[Note: Replace 80.2.9 as follows and renumber the section numbers appropriately.]

### 80.3 Service Interface specification method and notation

**Figure 80-2—40GBASE-R and 100GBASE-R Inter-sublayer Service Interfaces**

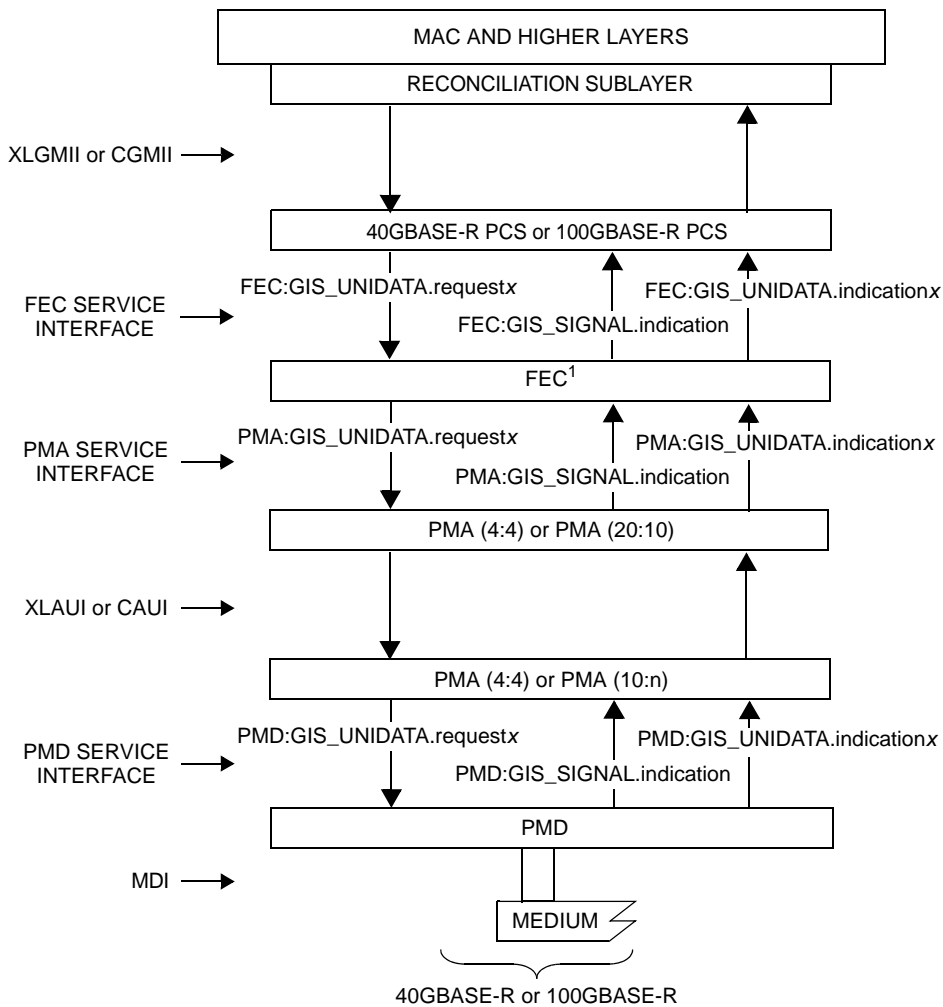
An example of inter-sublayer interfaces for 40GBASE-R and 100GBASE-R with their corresponding instance names are illustrated in Figure 80–2. For example, the primitives for one instance of the inter-sublayer service interface, named the PMD service interface, are identified as PMD:GIS\_UNITDATA.request $x$ , PMD:GIS\_UNITDATA.indication $x$ , and PMD:GIS\_SIGNAL.indication. Primitives for other instances, of inter-sublayer interfaces, are represented in a similar manner as described above.
